Customs Convention on the International Transport of Goods under Cover of TIR Carnets (TIR Convention, 1975):

Application of the Convention – Vehicles with sliding sheets

Vehicles with sliding sheets

Submitted by the International Association of the Body and Trailer Building Industry

Sketch No. 10

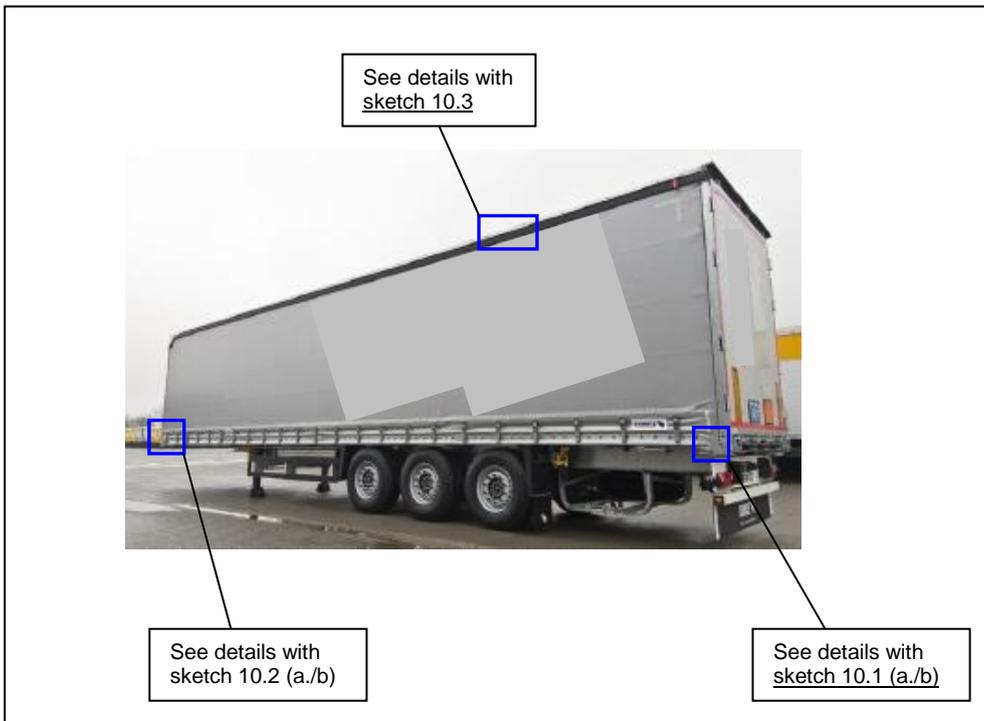
(iv) The sliding sheet guidance and other movable parts shall be assembled in such a way that when closed and Customs sealed, doors and other movable parts cannot be opened or closed from the outside without leaving obvious traces. The sliding sheet guidance and other movable parts shall be assembled in such a way that it is impossible to gain access to the load compartment without leaving obvious traces. The system is described in sketch No. 9 and No. 10 appended to these Regulations.

This sketch shows an example of a container and of important points described within Annex 7 – Part I, Article 5, Paragraph 3.

a) Ratchet securing

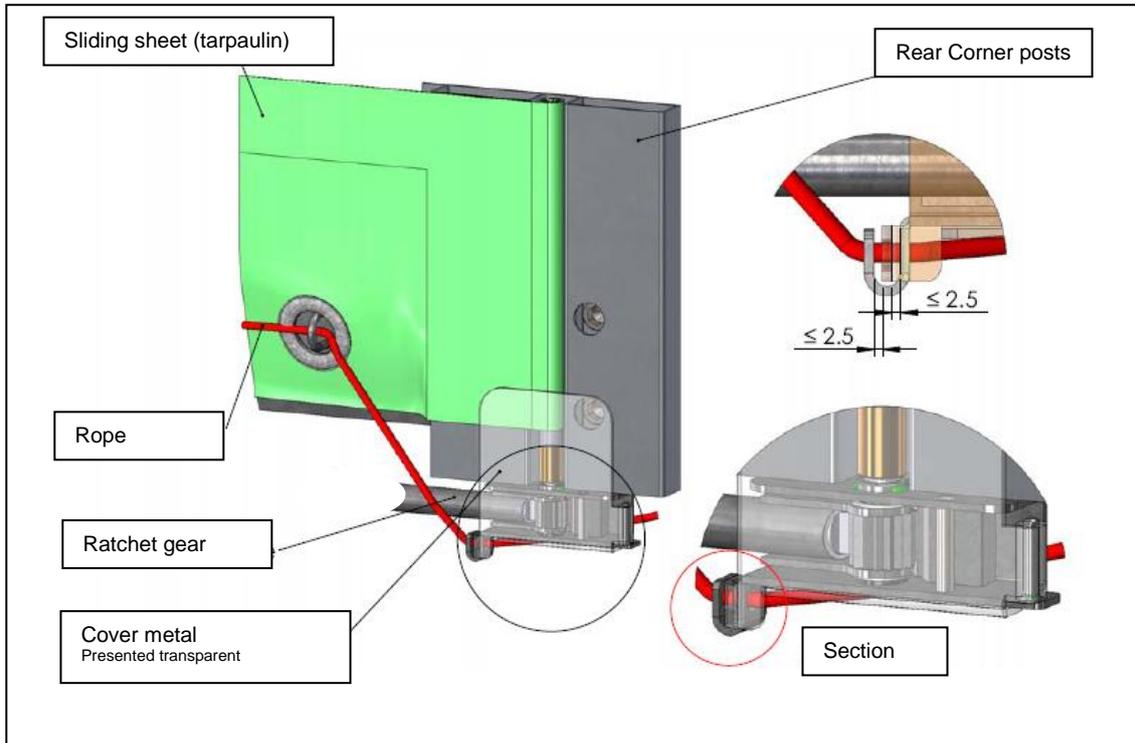
To tighten the tarpaulin in the horizontal direction, a ratchet gear is used (normally on the rear end of the container). This sketch shows two examples (a. and b.) how the ratchet or gearbox may be secured.

a) Cover metal

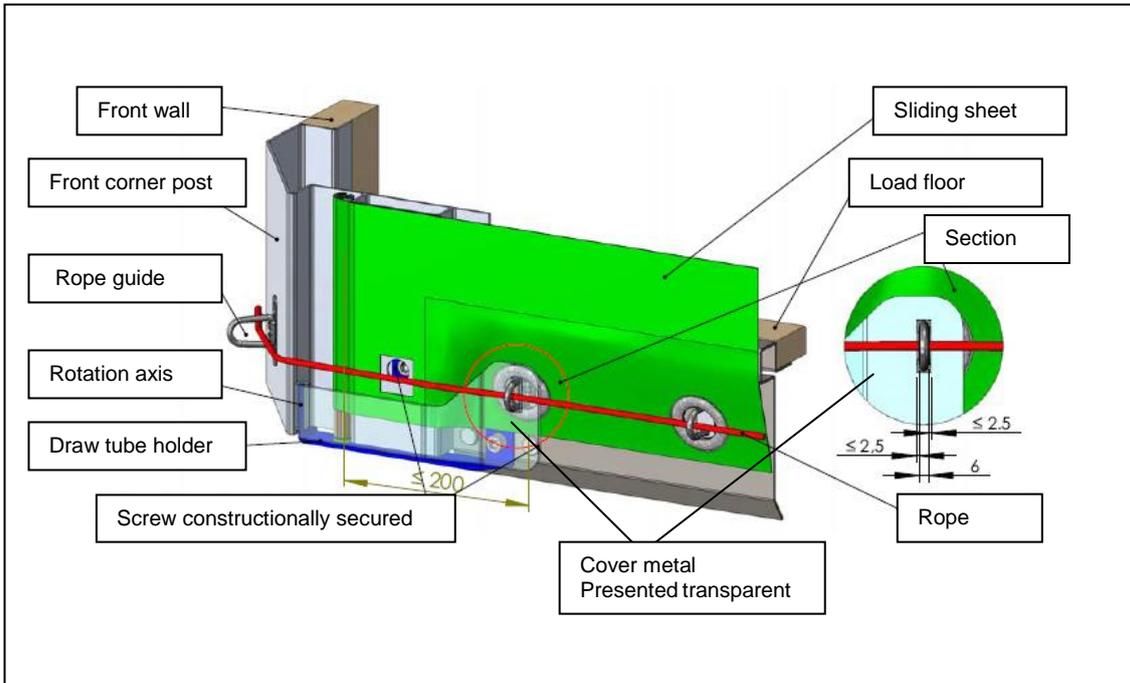
To fix the tarpaulin on the other side (normally to the front of the container) the following systems (a. or b.) may be used.

Sketch 10.3

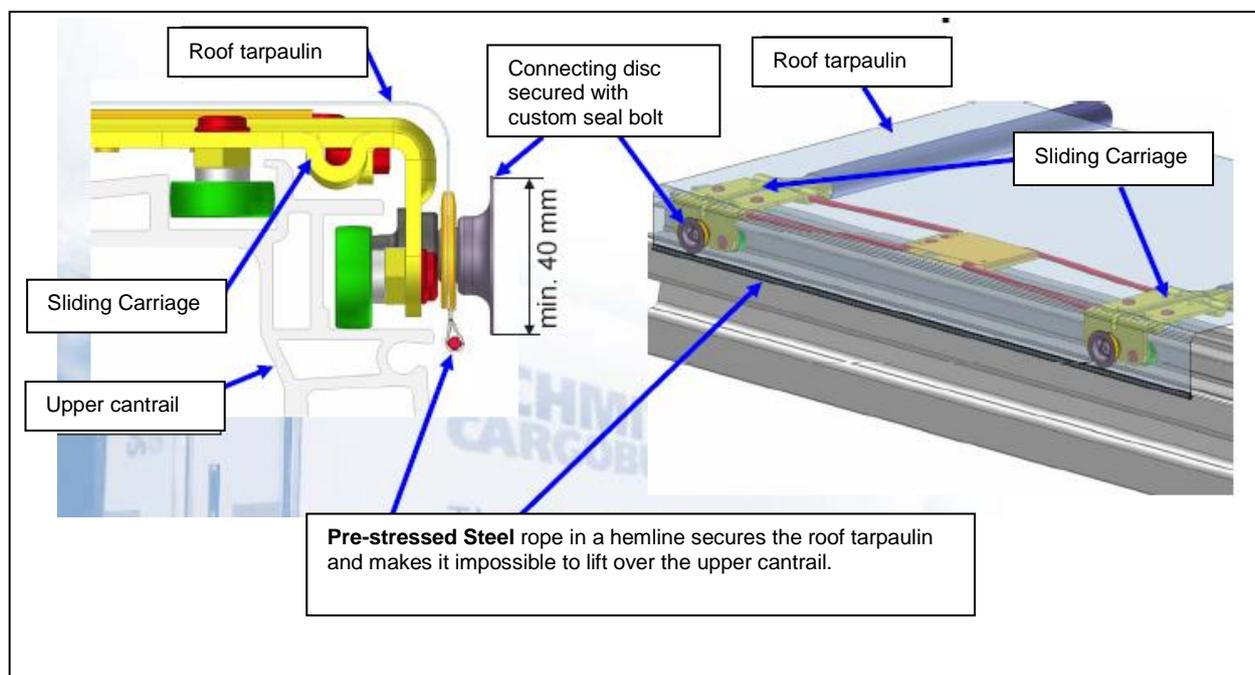
(iii) The sliding roof curtain shall overlap the solid part of the roof at the side of the container, so that the roof curtain cannot be pulled over the top edge of the upper cantrail. In the hemline of the roof curtain a pre-stressed steel rope (minimum $z_k 1770 \text{ N/mm}^2$, 6x19+SE) shall be inserted in such a way that it cannot be removed and re-inserted without leaving obvious traces. The roof curtain shall be secured to the sliding carriage in such a way that it cannot be removed and re-secured without leaving obvious traces. The system is described in sketch No. 10.3 appended to these Regulations.

The custom security of the sliding roof is guaranteed if a pre-stressed steel rope, embedded in a hemline, is fixed. This steel rope is fixed to the front and rear of the container. The tractive force as well as the connecting disc on each sliding carriage, makes it impossible to lift up the hemline with the steel rope above the upper cantrail.
